**Nuclear Fuel Services, Inc.**  
P.O. Box 337, MS 123  
Erwin, TN 37650

**Subject: Clarification of NFS' Responses to the RAI Supporting NRC's Environmental  
Review for the BLEU Project**

***Clarification of NFS' Responses to the Request for Additional Information  
Supporting NRC's Environmental Review for the BLEU Project***

***Updated Drawing Including Locations for Former Wells SC-7 and 82***

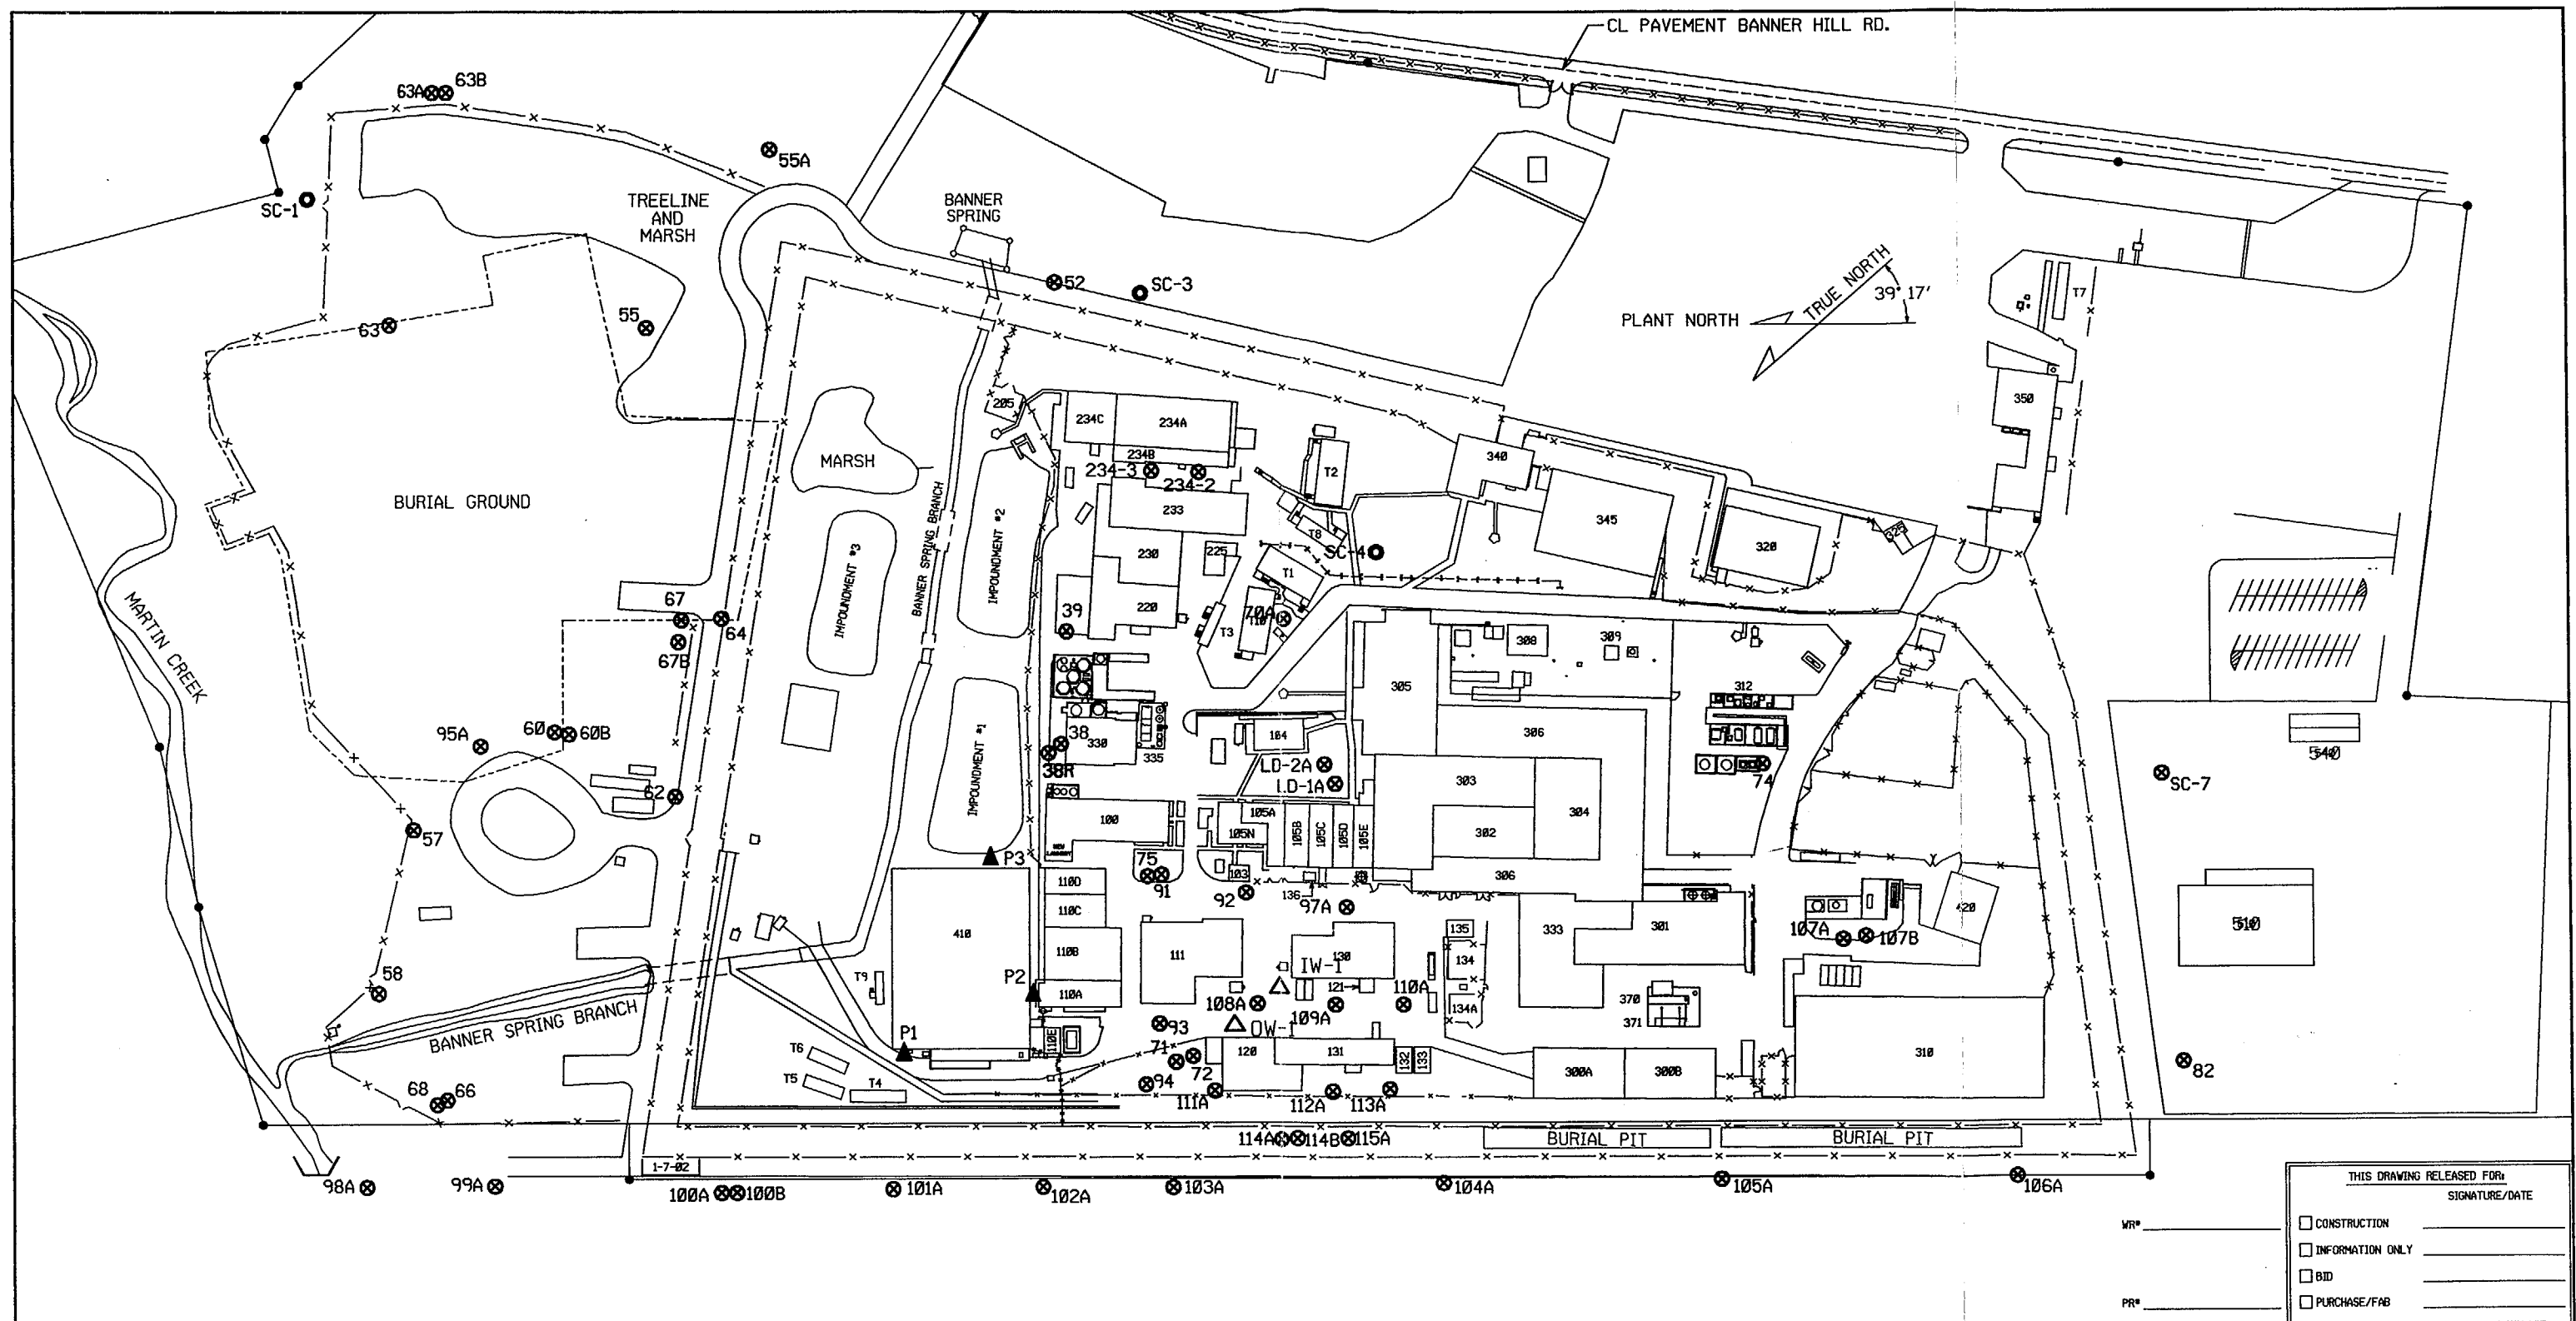
***NRC Comment 1: (RAI 7b) Some existing wells are missing from the current chart of groundwater monitoring wells. Even though NFS will propose new monitoring locations in the future (post EA), for the EA we requested an updated chart with the correct information. They [NFS] agreed to provide.***

**NFS Response to Comment 1:** Attachment V of the RAI Responses<sup>1</sup> provided a drawing that depicted monitoring wells locations at the NFS site including the BLEU Complex. There had been two wells, SC-7 and 82, on the land for the BLEU Complex. They were abandoned in August 2001 and, thus, were not included on the drawing. This drawing has been amended to show the former locations for wells SC-7 and 82 and is Attachment II of this submittal.
